ITEM 4. SECTION 96 APPLICATION: 137-151 CLARENCE STREET SYDNEY**FILE NO: D/2012/1453****DEVELOPMENT APPLICATION NO: D/2012/1453/A****SUMMARY****Date of Submission:** 25 November 2013**Applicant:** Investa Property Group**Architect:** Architectus**Developer:** Investa Property Group**Owner:** IOF Custodian Pty Limited**Cost of Works:** \$99,969,678

Proposal Summary: The subject Section 96 application seeks to modify an approved Stage 1 building envelope, to reduce the setback of all levels above podium height to 4 metres from the Kent Street (western) boundary of the site.

Figure 20: A cross section of the proposed modified building envelope, illustrating a 4-metre setback to Kent Street for all tower floor levels

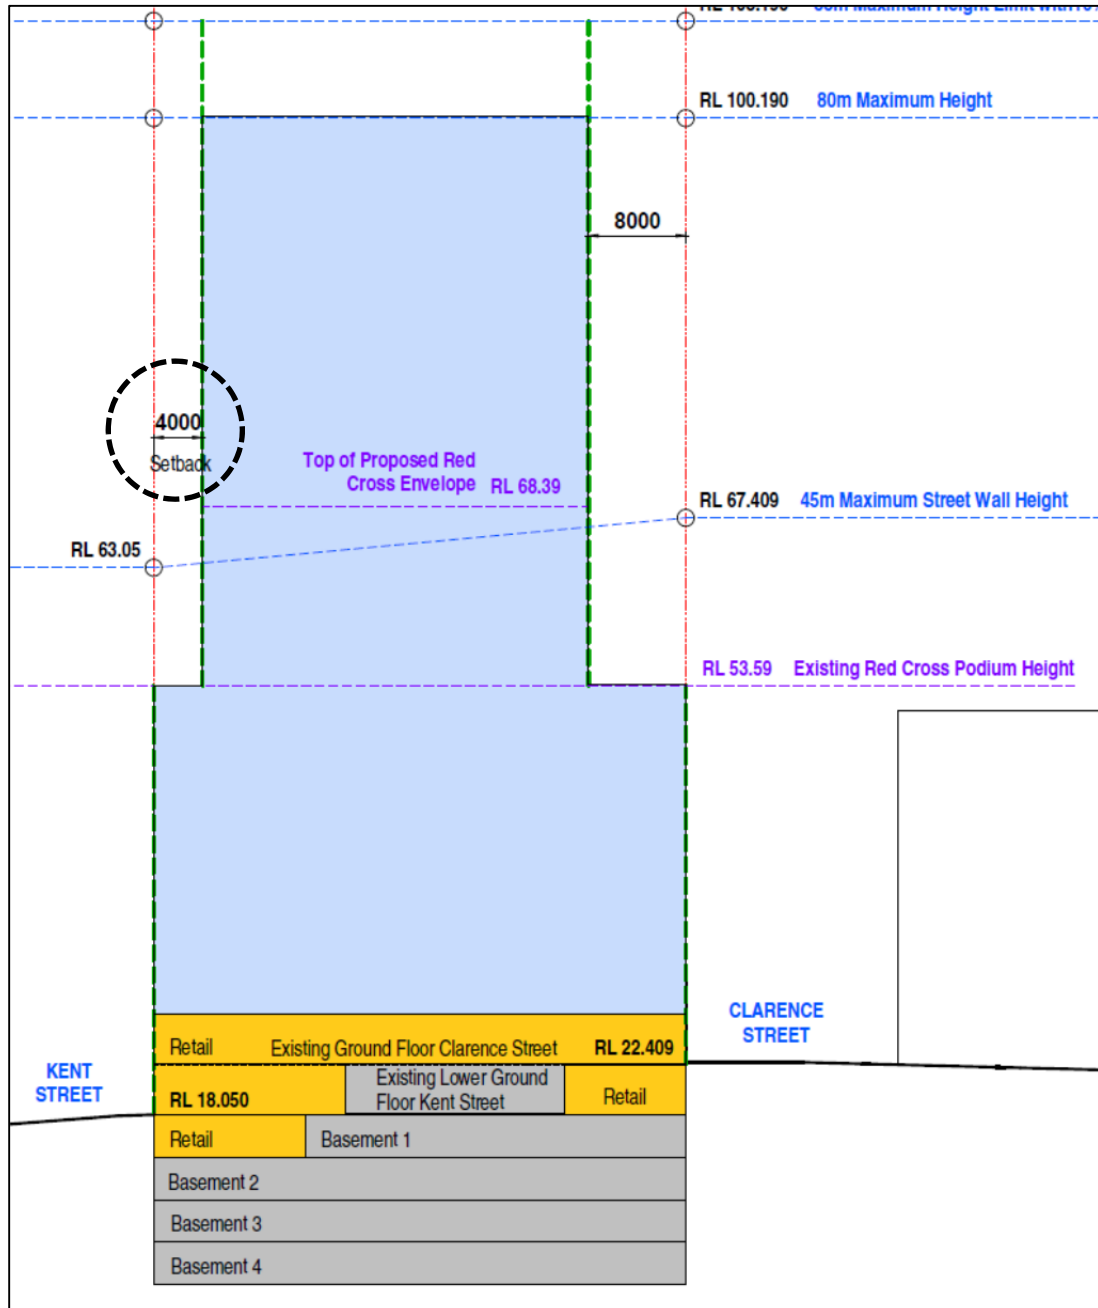
- 23. The subject Section 96(2) application seeks consent to modify the approved Stage 1 building envelope to reduce the setback of the high-rise tower levels from its Kent Street (western) frontage from 8 metres to 4 metres. **Figure 20**, below, illustrates the proposed 4 metre setback of this tower envelope from the Kent Street boundary in section.
- 24. The proposal does not seek to alter the remainder of the building setbacks, the building envelope or its height from that approved by the CSPC in December 2012.

Figures 21 and 22: The approved (left) and proposed (right) Stage 1 building envelope, illustrating the modified Kent Street setback for the tower levels

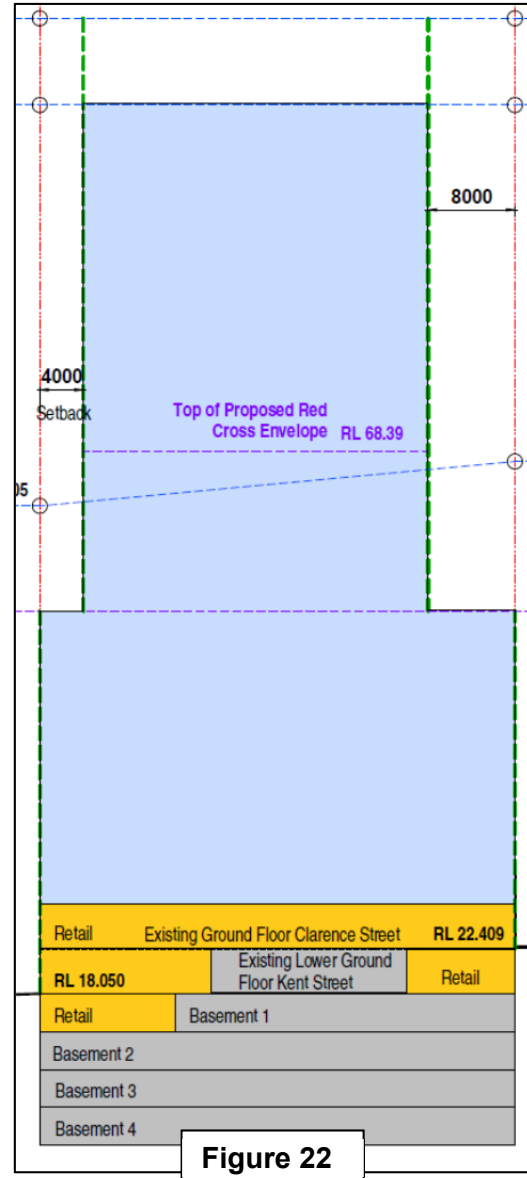
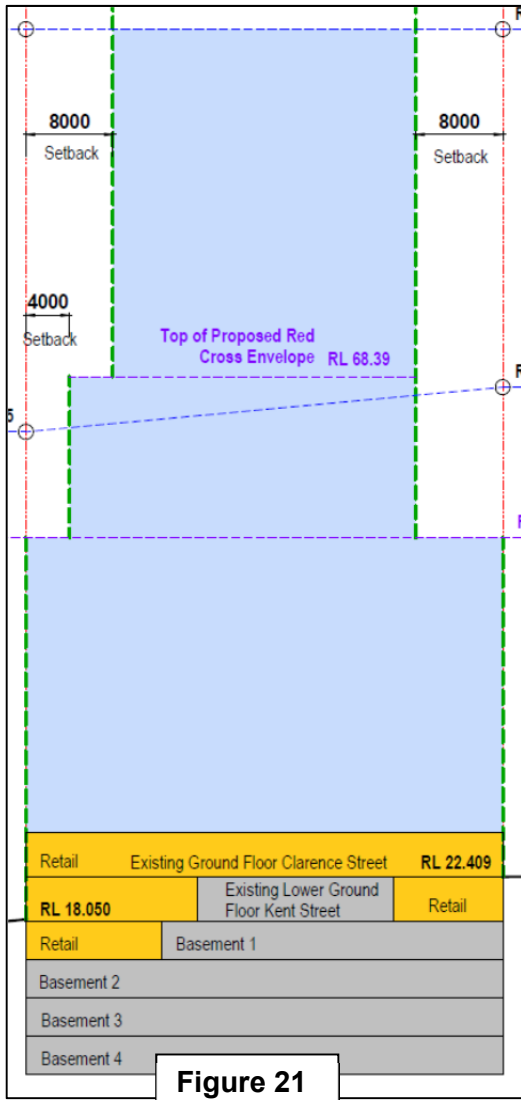
35. **Figures 21** and **22**, below, provide a comparison of the approved building envelope and its setbacks (in section) from both its street frontages and the proposed modification to the above podium level setbacks from the Kent Street frontage of the site.

37. The current modification that is the subject of this application has been lodged to delete the approved stepped setback of the mid-tower levels (of approximately 4 commercial floor levels) and adopt a 4 metre setback from the Kent Street frontage of the site.

38. Whilst this represents a numeric departure from the 8 metre front setback control of Section 5.1.2.1, it is considered that the variation can be supported in this particular instance as the proposal still achieves the objectives for setbacks as outlined at Section 5.1.2 of SDCP 2012, in the following manner:

Figure 23: Proposed 4 metre setback on Kent Street frontage illustrated in context of recent approvals for Red Cross House and 161-165 Clarence Street

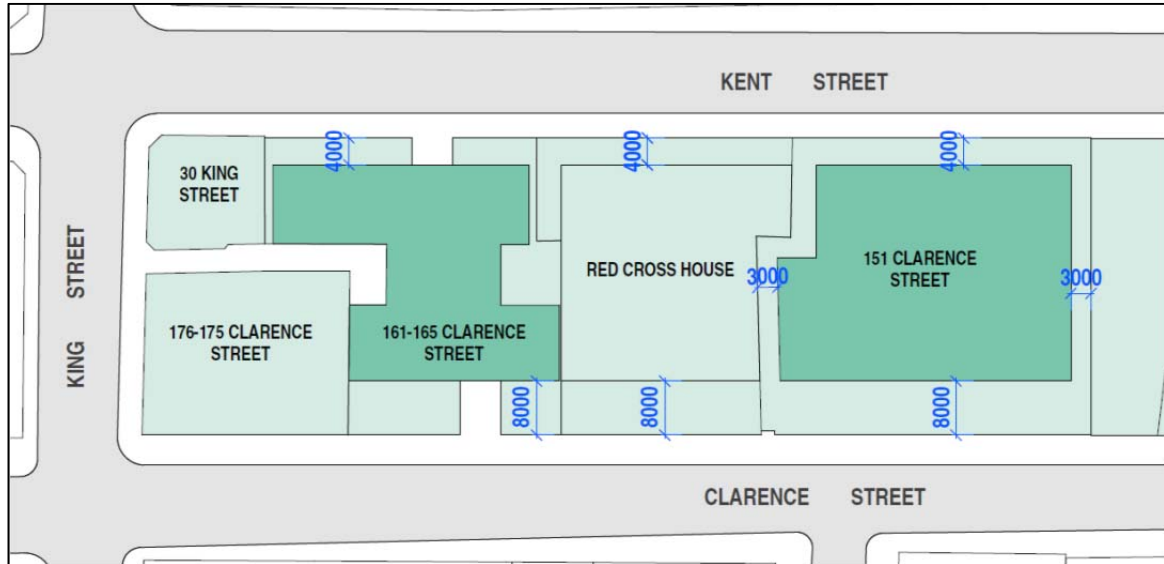
- (a) The variation of the approved building envelope to adopt a 4 metre setback for all above podium floors on its Kent Street frontage is consistent with recent approvals on adjacent sites (as detailed in **Figure 23**, below) and is contextually appropriate;

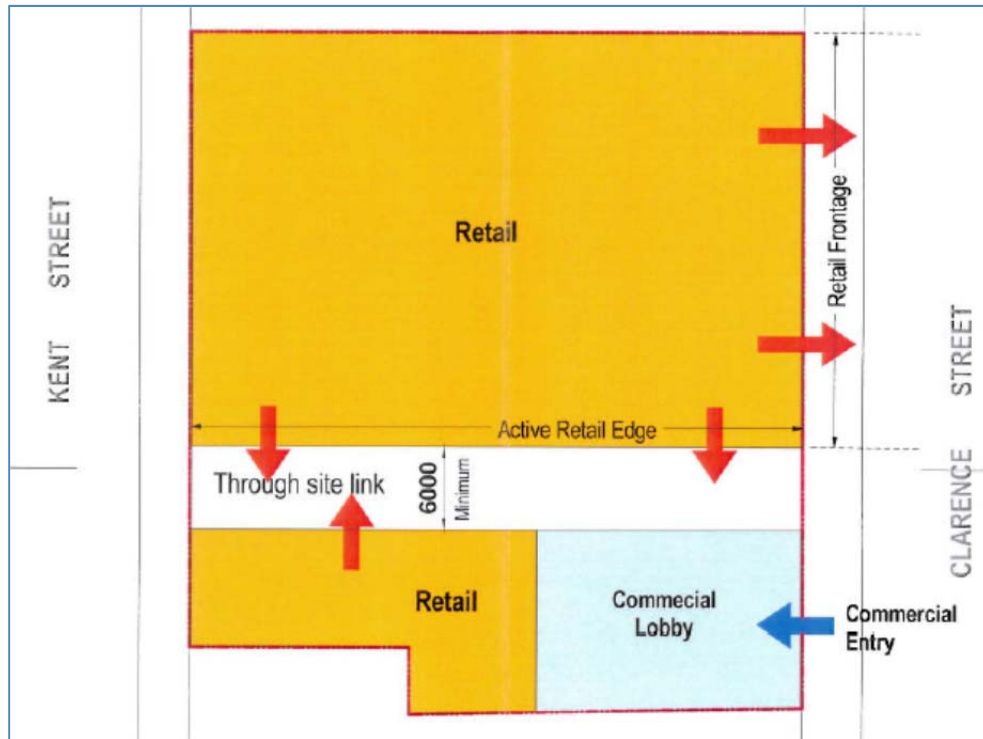
- (b) Despite the reduced setback on Kent Street, the proposed future commercial floor plates would retain a separation of approximately 45 metres to the existing commercial tower on the opposite side of Kent Street, which is in excess of the DCP requirements;

Figure 25: The indicative ground floor layout of the winning scheme from the competitive design process

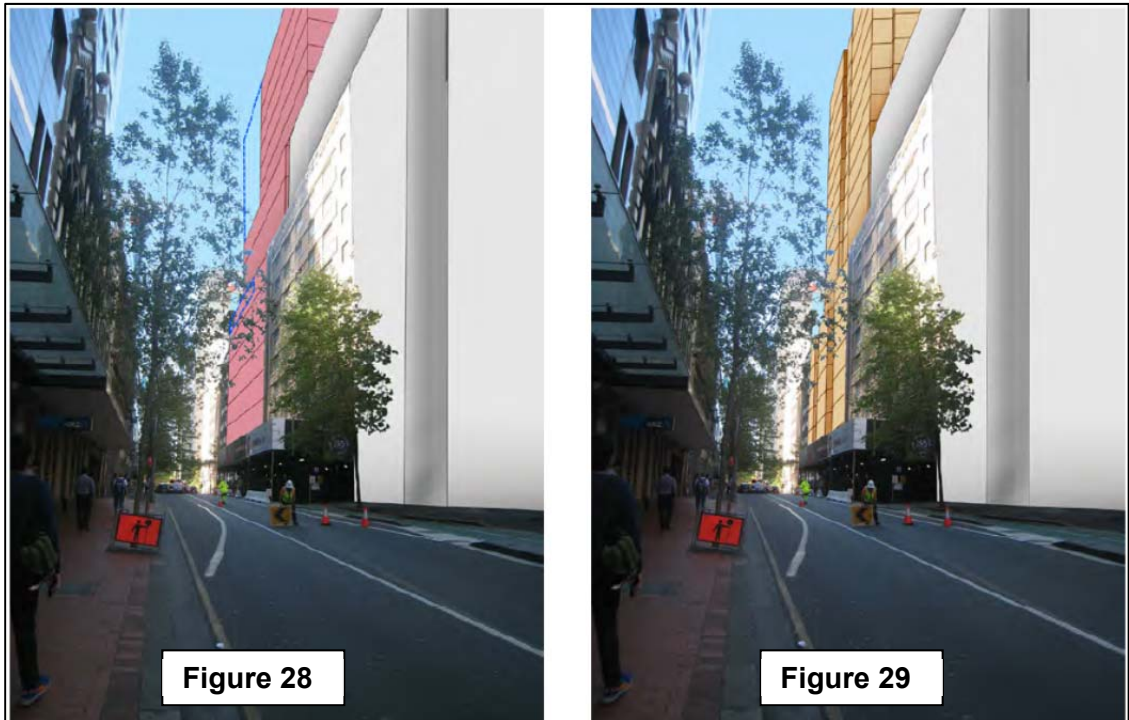
- (d) Whilst the internal floor plans and layouts will form part of the detailed assessment of a further Stage 2 DA, it is noted that despite the variations in envelope to increase the size of the floor plates in the tower, the floor space will remain permissible with the maximum allowable under Sydney Local Environmental Plan 2012 (as detailed in **Figure 25** below). The design competition winning scheme and Stage 2 DA to be lodged will offset this floor space by:

- (i) the provision of greater pedestrian penetration and public access through the site at ground level;
 - (ii) inclusion of double height voids to the through-site links, reducing the floor plates at level 1 of the development;

- (iii) provision of a void/lightwell throughout the building to increase light penetration to the commercial floor plates; and
 - (iv) articulation of the building facades.
